Re: Strata Energy Ross In Situ Recovery Project
Source Materials License SUA-1601, Docket No. 040-09091
Response to Comments on Submittal for License Condition 12.10

ROSS URANIUM PROJECT SOURCE MATERIALS LICENSE SUA-1601 Response to NRC Comments on Strata Quality Assurance Plan

Appendix 2 – Strata Organization

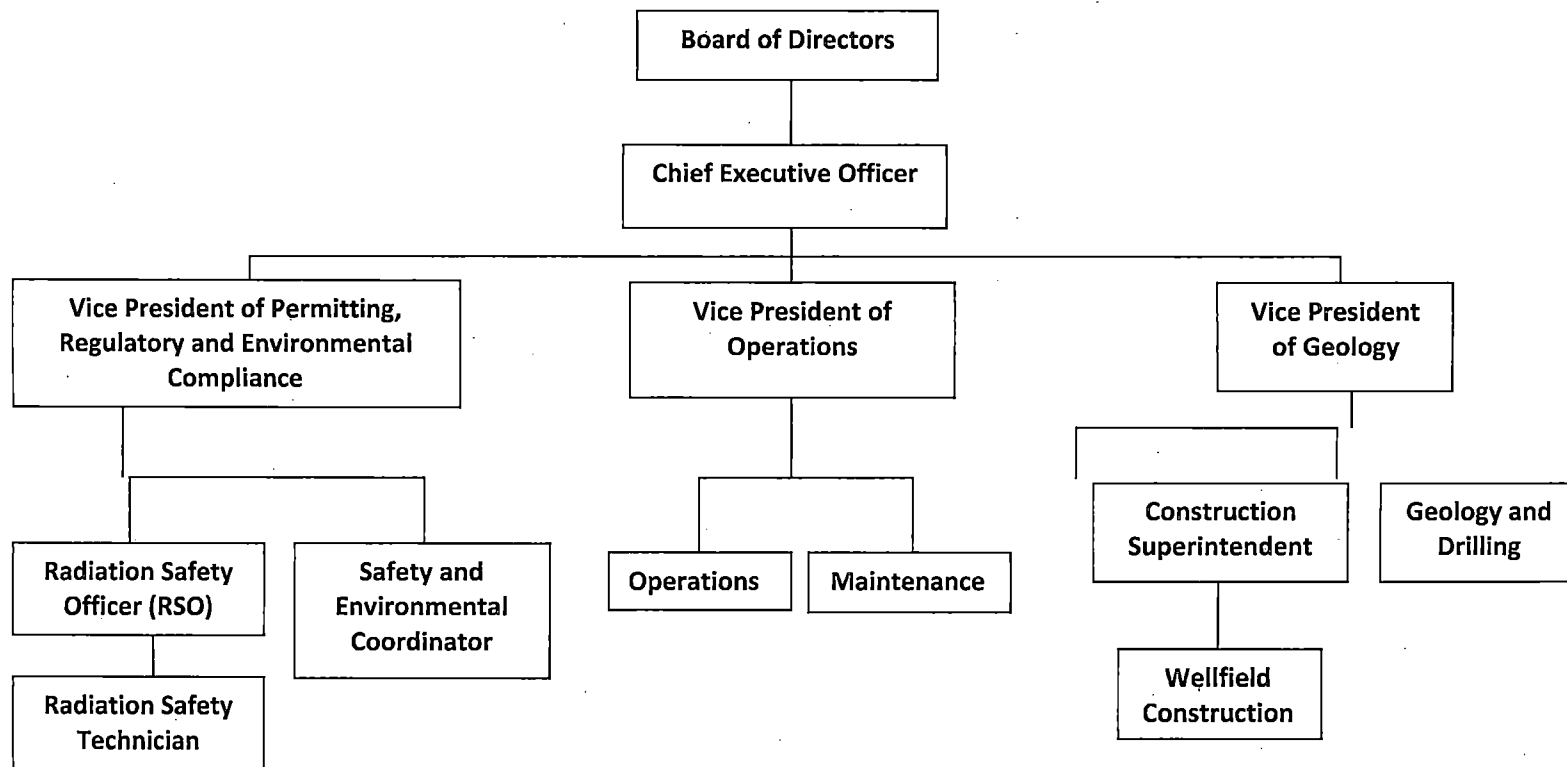
The key positions identified in Section B.3 are inconsistent with the management organization described in Strata's Technical Report (Strata 2011a) and approved in Strata's license (NRC 2014). Please revise the QAP to be consistent with the NRC-approved organization and explain the quality-related functions of the senior management positions described in the Technical Report, but not described in Revision 0 of the QAP.

The Technical Report (TR) was prepared in 2011 and reflected the expected organizational structure at that time. Since 2011, Strata has refined the management organization in regards to job titles and, in the case of the Chief Executive Officer, assigned responsibilities. A revised organization chart based on TR Figure 5.1-1 is included as Appendix 2. The job titles from the TR have been changed as follows:

- The Chief Operating Officer is now the Chief Executive Officer (CEO).
- The Manager of Health, Safety and Environmental Affairs is now the Vice President of Permitting, Regulatory, and Environmental Compliance.
- The Operations Superintendent is now the Vice President of Operations.
- The Chief Geologist is now the Vice President of Geology.

The overall functions and responsibilities are unchanged from those reflected in the Technical Report with the following exceptions:

- The CEO now fulfills the functions originally defined for the Chief Operation Officer (COO), General Manager, and Facility Manager.
 - The Construction Superintendent now reports to the Vice President of Geology.

- The reporting organization, responsibilities, and functions of the Radiation Safety Officer have not been affected by these changes. The revised organizational chart was approved by the Strata Safety and Environmental Review Panel in SERP-15-18. The proceedings of all SERP reviews conducted by Strata since issuance of SUA-1601 are available for inspection. In addition a copy of each SERP proceeding and changes to the TR as a result of these approvals have been requested by NRC and are being compiled for a submittal to support preparation for the preoperational inspection. The organization discussed in Revision 0 of the Strata QAP reflects the organization that was approved by the SERP. Quality-related functions as described in the TR are included in Revision 1 of the QAP.
